6 National Dam Inspection Program. Number
Musser Forests Dam (NDIVPA-287,
DER IDV 32-65), Ohio River Basin, McKee
Run, Indiana County, Pennsylvania.

PHASE I ~~REPORT~~ Inspection Report,
NATIONAL DAM INSPECTION PROGRAM

NAME OF DAM: Musser Forests Dam
STATE LOCATED: Pennsylvania
COUNTY LOCATED: Indiana
STREAM: McKee Run
SIZE CLASSIFICATION: Small
HAZARD CLASSIFICATION: High
DATE OF INSPECTION: May 23 and 25, 1979

MUSSER FORESTS DAM
NDI I.D. NO. PA-287
MAY 23, 1979

PLATE 3

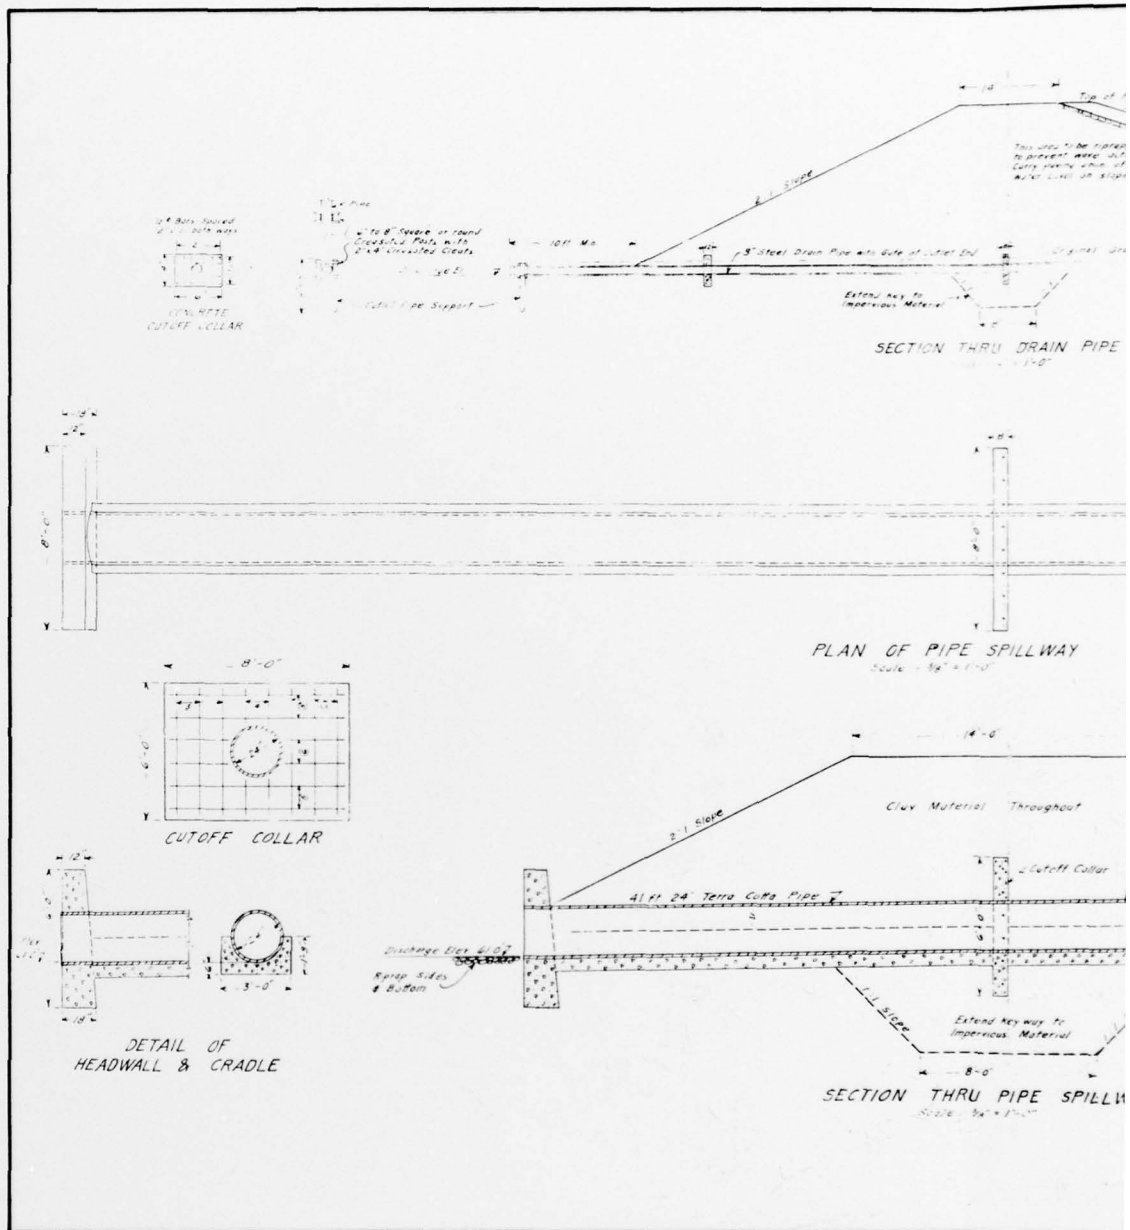
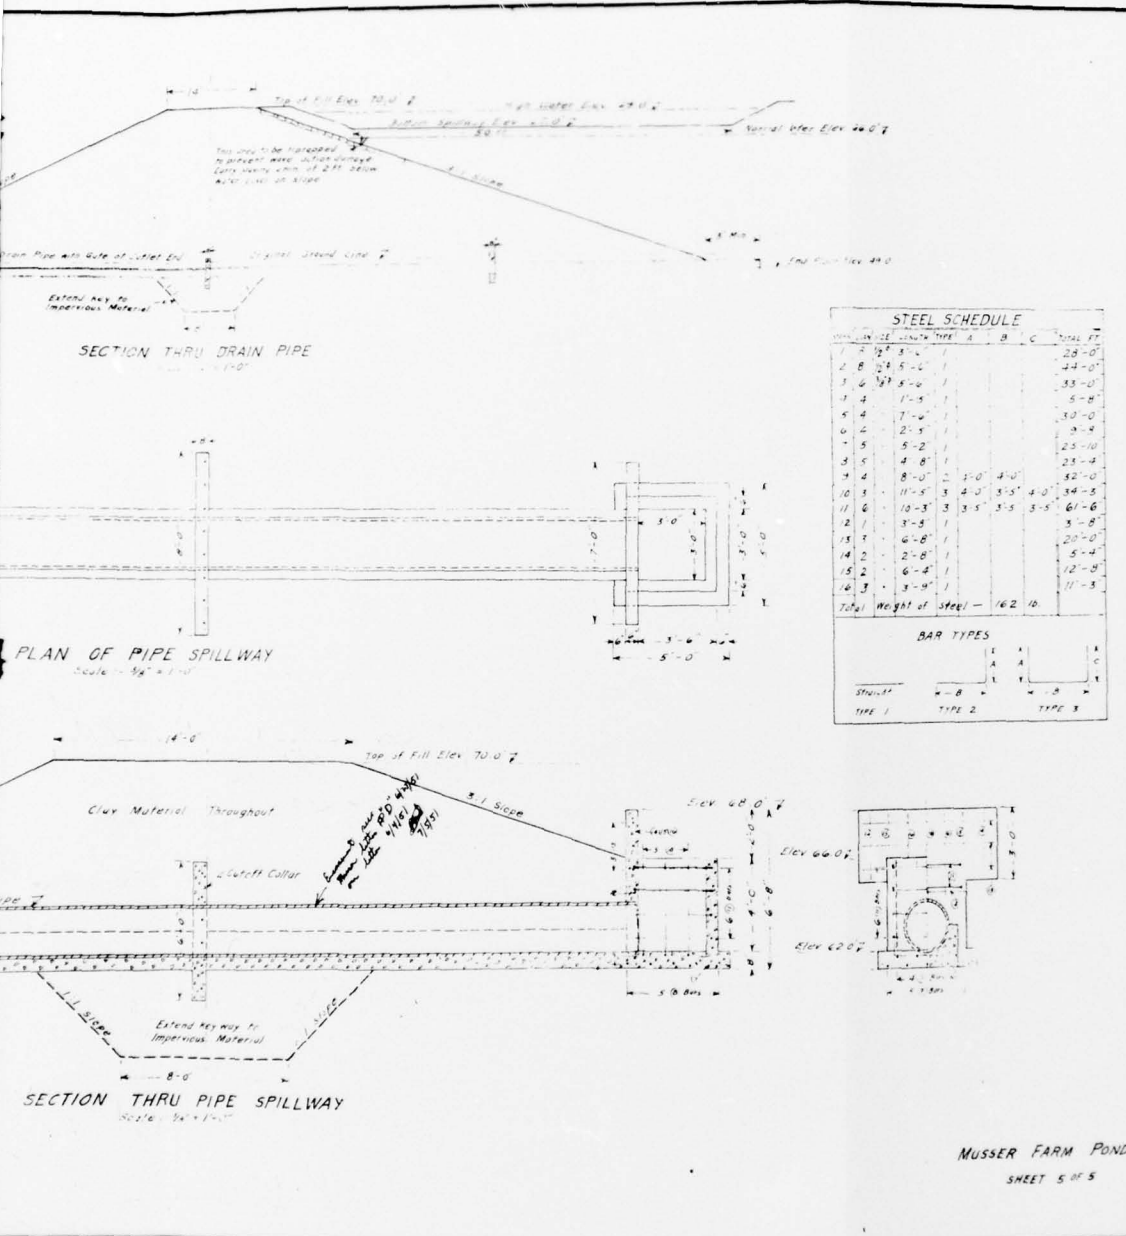
The pipe is reported to be encased in concrete. Plate 3 illustrates the details of the primary spillway and outlet pipe. The profiles of the primary and emergency spillways and the cross sections of the emergency spillway discharge channel are shown on Plates 4 and 5.

PLATE 6
 MUSSER FORESTS DAM
 GENERAL PLAN
 FIELD INSPECTION NOTES
 FIELD INSPECTION DATE: MAY 23, 79

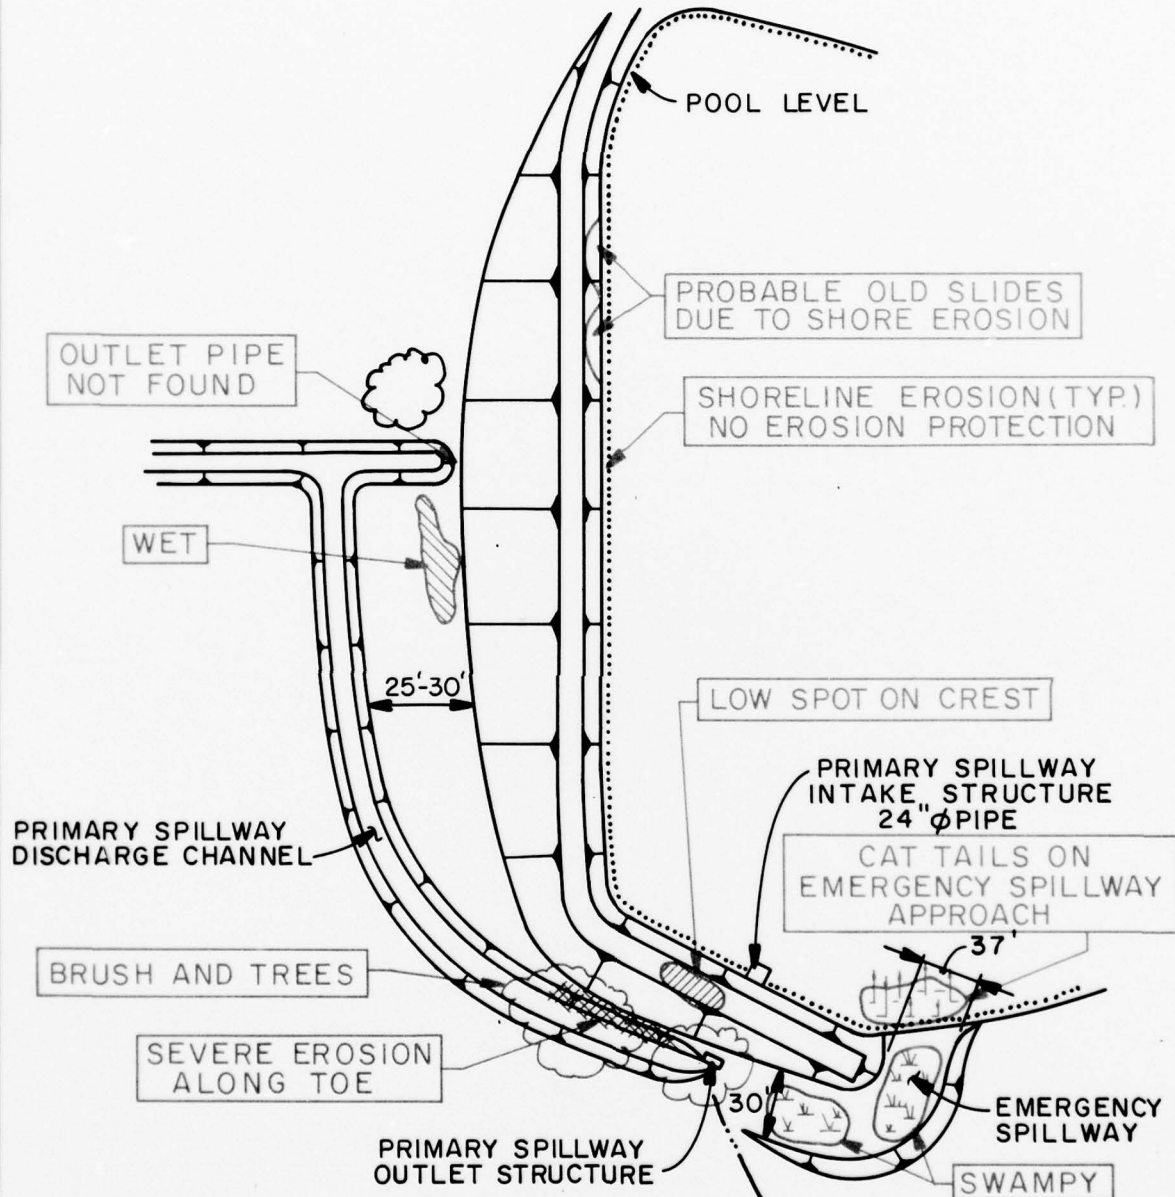
The specific observations are illustrated in Plate 6 and in the photographs in Appendix C.

Discharge through the primary spillway discharge channel which follows the toe of the embankment near the left abutment was found to be eroding the embankment toe. At some sections, the toe of the embankment appears to be cut 4 to 5 feet deep by this erosion. This condition is considered to constitute a threat to the integrity of the embankment if allowed to continue. The condition of the remaining portion of the embankment is considered to be fair. The crest of the dam was found to be irregular. However, the irregularities do not appear to be from recent movements. The upstream slope of the dam has no erosion protection and has eroded due to wave action. A wet area was observed at the toe level of the dam at the center of the main embankment. No measurable seepage appears to be associated with this wet area.

The emergency spillway approach channel was found to be overgrown with tall grass and cattails which may obstruct flow through the emergency spillway. The spillway discharge channel downstream from the primary spillway was also found to be overgrown with brush and trees which also may constitute obstruction to flow. Although the design drawings show the base width of the emergency spillway to be 50 feet, the field measurements show the base width of the emergency spillway to be approximately 37 feet. The visible portions of the primary spillway structures were inspected and found to be in fair condition.

PLATE 7

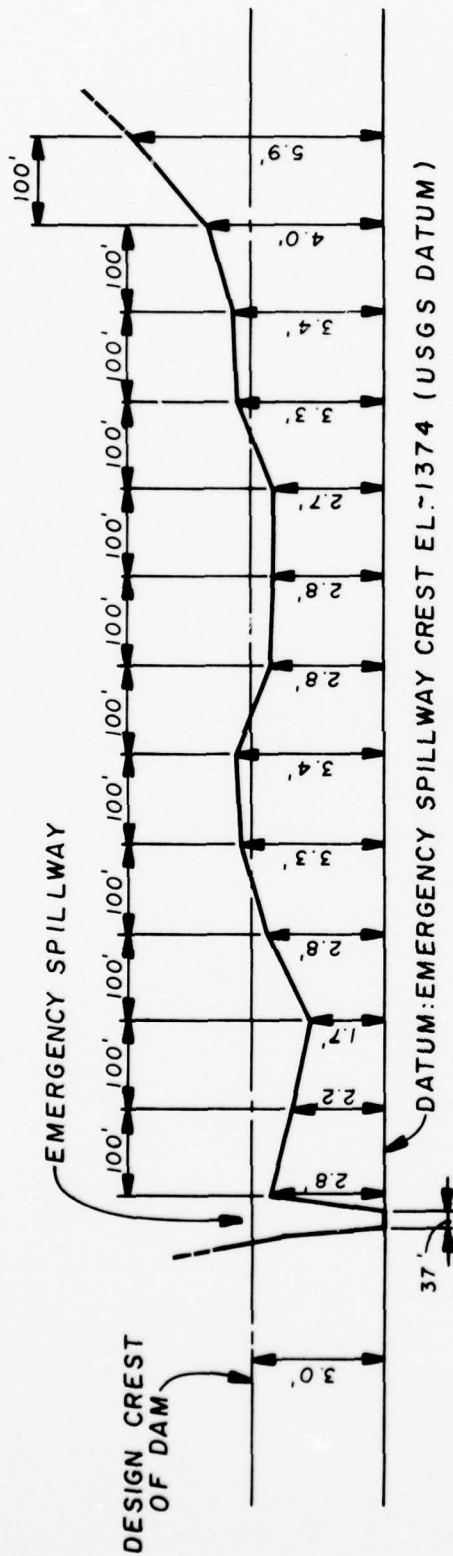
The crest of the dam was surveyed relative to the emergency spillway crest level. The freeboard was found to range from 1.7 feet in the vicinity of the primary spillway to 5.9 feet near the right abutment. The dam crest profile is illustrated on Plate 7.

2. The owner should immediately initiate additional studies to more accurately ascertain the spillway capacity and the nature and extent of improvements required to provide adequate spillway capacity. Filling of the low spots on the crest of the dam should be considered in conjunction with these studies.
3. Erosion protection, such as riprap, should be provided on the upstream slope of the dam.
4. Vegetation in the emergency spillway approach channel should be immediately cleared.
5. Around-the-clock surveillance should be provided during unusually heavy runoff and a formal warning system should be developed to alert the downstream residents in the event of emergencies.
6. The dam and appurtenant structures should be inspected regularly and necessary maintenance performed.
